Green Oak Charter Township Planning Commission Regular Meeting Thursday, March 7th, 2024 7:00 p.m.

Preliminary Site Plan / Special Approval Use Review for

Re: Legacy Center Wellness Building—Preliminary Site Plan and Special Land Use Request

PARKING LOT FIXTURE DETAIL (TYP.)

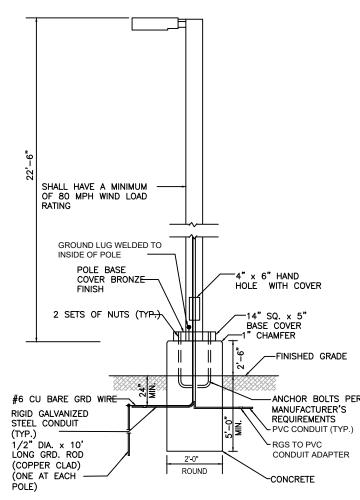
Both photometric plan sheets indicate that the pole-mounted lights are mounted at twenty-five (25') feet. Section 38-364(e)(1) indicates that the maximum height of pole light fixtures shall be twenty (20) feet. The applicant indicates that they are consistent with exiting poles at the site. However, It is not clear that this was an approved deviation from the ordinance in the approved PUD.

- 4. The photometric plan for the wellness center has been added to the plan set as Sheet A-002. The pickleball courts have no proposed lighting.
- 5. The proposed pole heights are consistent with the other existing poles throughout the site that were previously approved for other phases. This is included in a box note in the upper right corner on the [Parking Lot] Photometric Plan, Sheet C16.

A-002

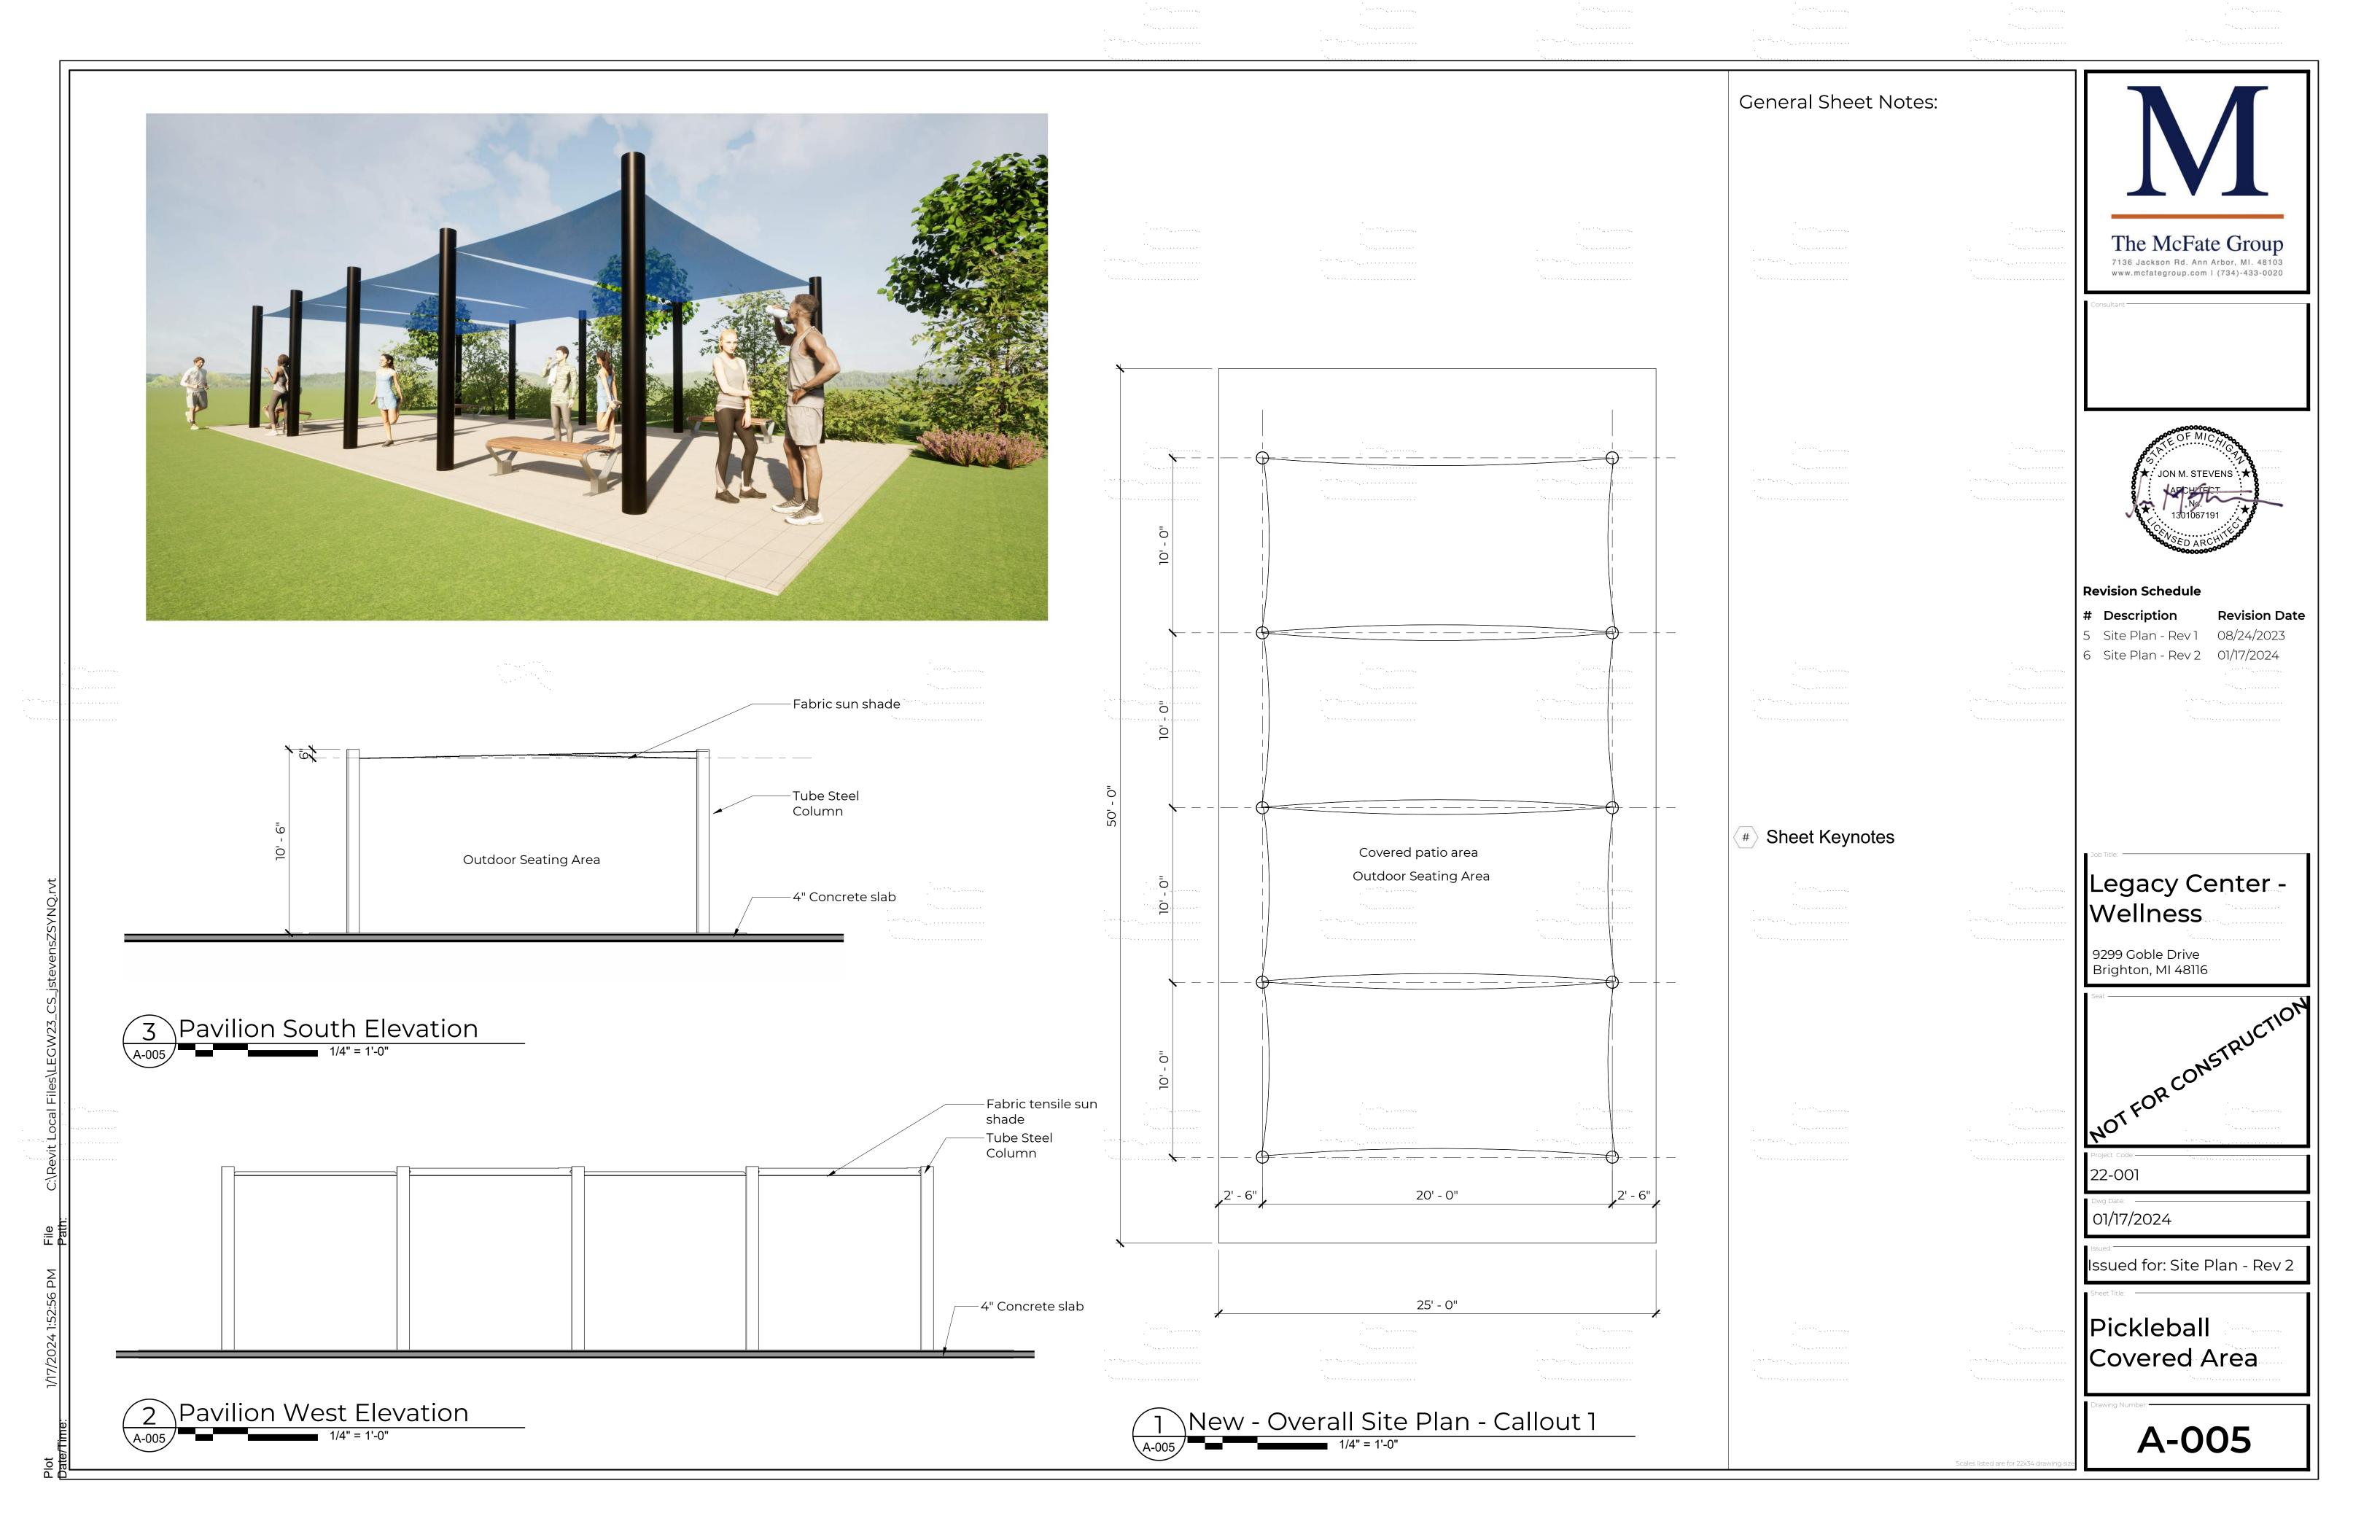
The January 17, 2024 site plan includes a lighting plan and a photometric map on A-002 as well as the previous photometric map and lighting plan of the parking lot extension on Sheet C16. These two sheets offer conflicting information that the applicant should address by providing a single, updated lighting plan.

Sheet C16 indicates that four (4) wall-mounted lights will be placed on the east side of the wellness center, but Sheet A-002 shows an additional six (6) wall-mounted lights on the south side of the wellness center. Sheet A-002 indicates that the lights will be mounted at twelve (12) feet. Details on how these lights will be shielded are not offered.

Sheet A-002 indicates that seventeen (17) pole-mounted lights are proposed throughout the parking lot extension. Sheet C16 shows only eleven (11) pole-mounted parking lot lights of two (2) different varieties.

The two photometric plan sheets also provide differing illumination values throughout the parking lot extension which should be clarified with a single new photometric grid. Furthermore, the photometric map only indicates the illumination for the parking lot extension and areas to the south and east of the proposed wellness center. Section 38-364 of the zoning ordinance requires the inclusion of a photometric grid overlaid on the proposed site plan, indicating the light intensity throughout the site.

- 6. The photometric plan for the wellness center has been added to the plan set as Sheet 16A. It includes information for the shielding of the lights on the exterior of the wellness center.
